Airspace Regulation

30 March 2016

BURBO BANK TMZ - PROPOSED EASTERN BOUNDARY CHANGE

APPENDIX A

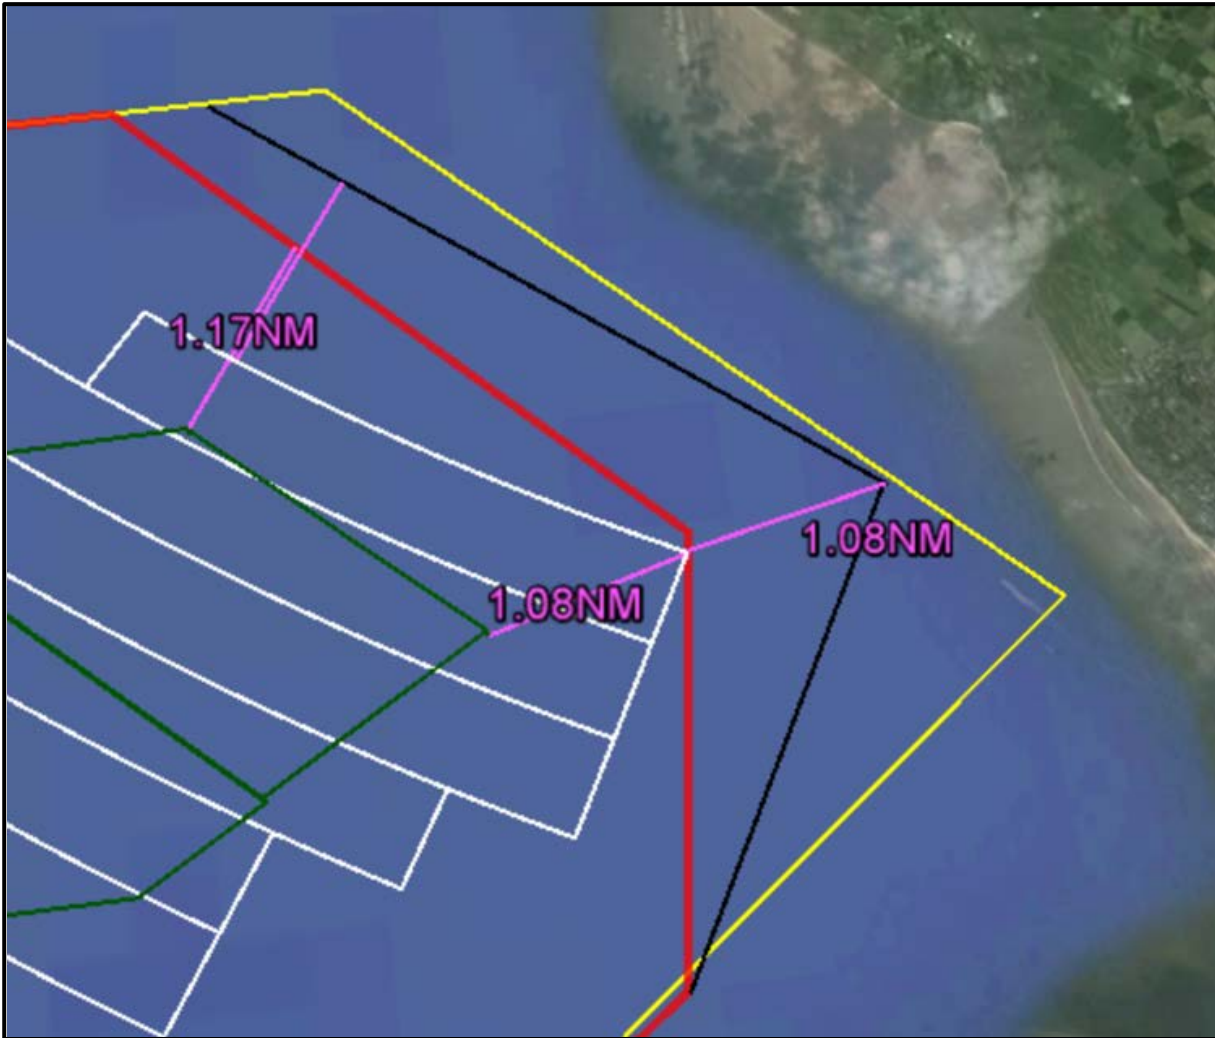
1.6. In order to retain an eastern buffer between the blanked area (white lines at Appendix A) and the TMZ boundary, OCSL on behalf of the Sponsor sought to revise the agreed eastern boundary to that shown by the black line in Appendix A.

1.9. However, on this occasion the CAA has taken a decision not to support an amended eastern boundary closer to the coast. It is our judgement that the risk of creating an unwelcome bottleneck for GA aircraft outweighs the risks associated with those issues that could be induced by the lack of a buffer at the extreme eastern point of the TMZ. We believe this decision appropriately balances the needs of all airspace users without increasing levels of safety. However, we accept that this might, on a very small number of occasions, require some limit to the service provided by Warton to aircraft operating in the immediate area.
